# Technical Memo

<b>To:</b>	Neil Harkin (Resource Consent Planner)
<b>From:</b>	Richard Powell (Infrastructure Development Engineering Manager)
<b>Date:</b>	Wednesday, 17 December 2025
<b>Subject:</b>	<b>Fast-Track Approvals Act 2024 - s53 Comment Technical Memorandum – Property &amp; Infrastructure</b>

Image 1: Scheme Boundary and subject site

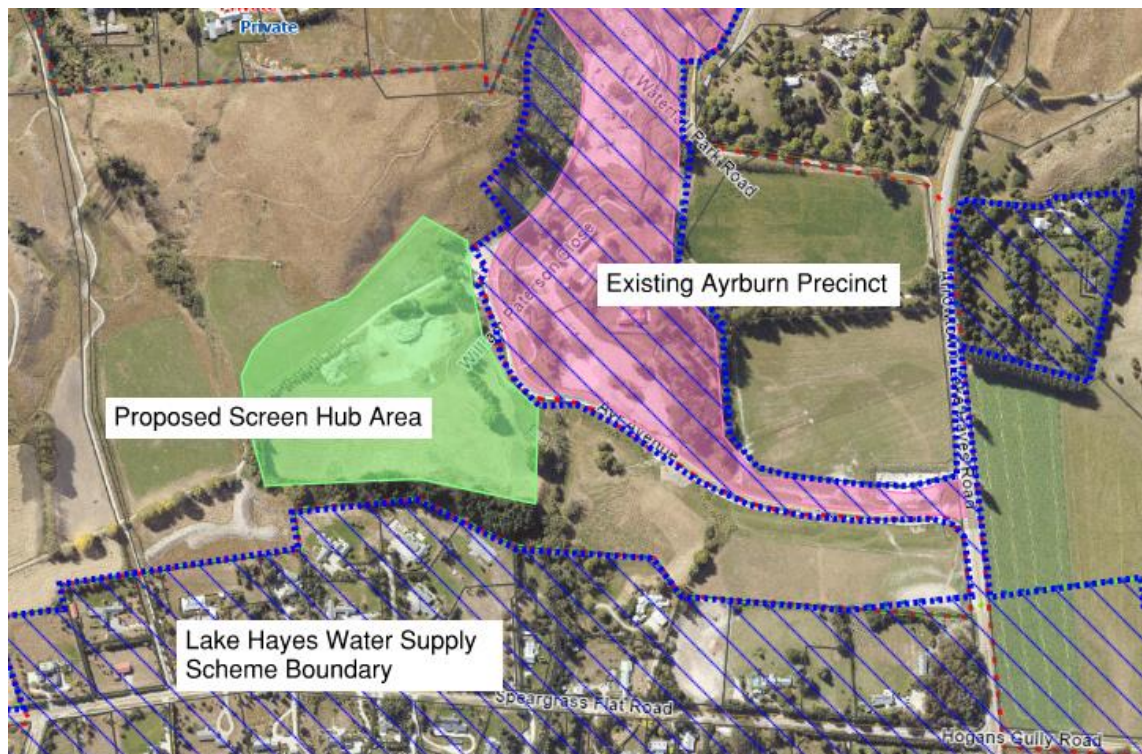
There is insufficient capacity within the Lake Hayes Scheme to service the proposed development.

Appendix 16 provided with the Screen Hub application is based upon a 2018 water supply modelling report which identified an allocation of 45 litres per second water supply capacity as being available within the Lake Hayes Scheme to service development within Waterfall Park and Ayrburn. That modelled capacity has progressively been allocated as development land use consents have been granted within the Lake Hayes Scheme and the Ayrburn precinct, and it is out of date.

**Image 2: Network components**

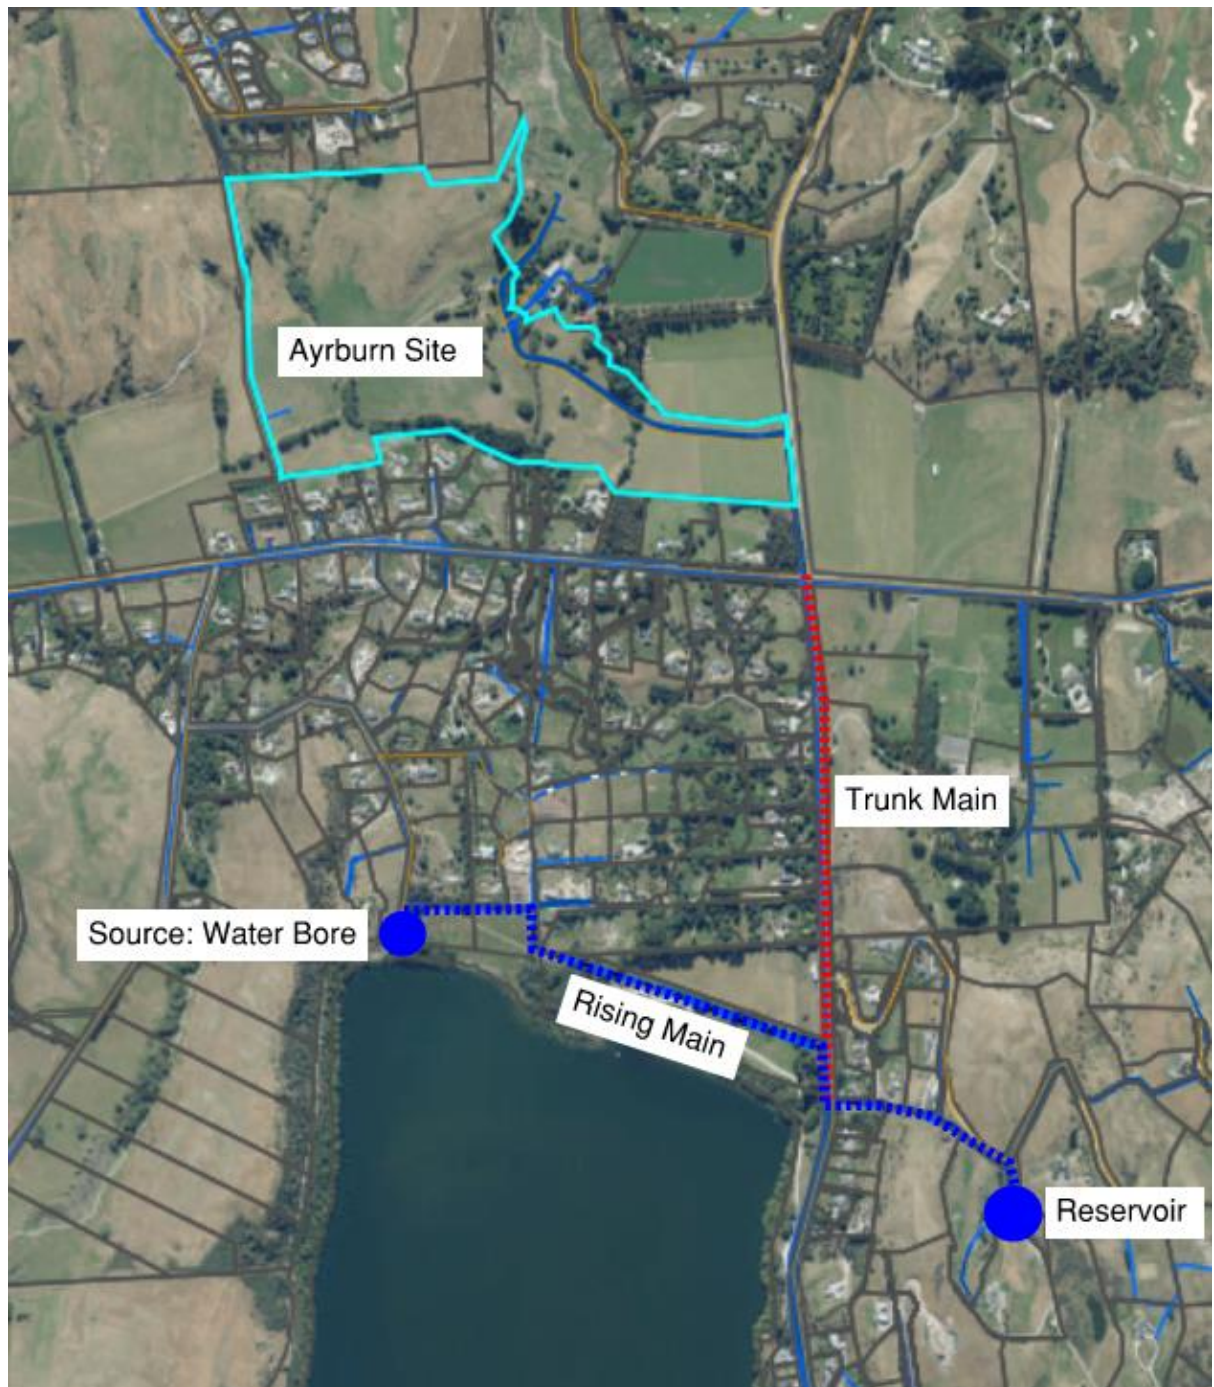
There are four critical components that likely require upgrading in order to provide water to the Project:

- **Source:** The bore and pumps located at the northern end of Lake Hayes must be capable of providing additional water. This will require that a new consent be sought from ORC to increase the capacity of water that can be taken.
- **Rising main:** A modelling assessment will need to be undertaken to confirm if the rising main is suitably sized to convey the increased flowrate from the Source to the Reservoir.

- **Reservoir storage:** Additional storage capacity within the network is required.
- **Trunk Main:** Approximately 1.2 km of water pipe along Arrowtown–Lake Hayes Road needs upgrading or duplication due to high head losses.

Without full knowledge of the required upgrades, which will not be clear until the recalibrated and updated modelling is available in March 2026, and given that QLDC has no allocated funding for these upgrades at present, it is recommended that a condition of consent be imposed to deal with this situation.

I have reviewed the condition recommended to be imposed as shown in the QLDC condition set and I consider it to be appropriate from a technical perspective in this case.
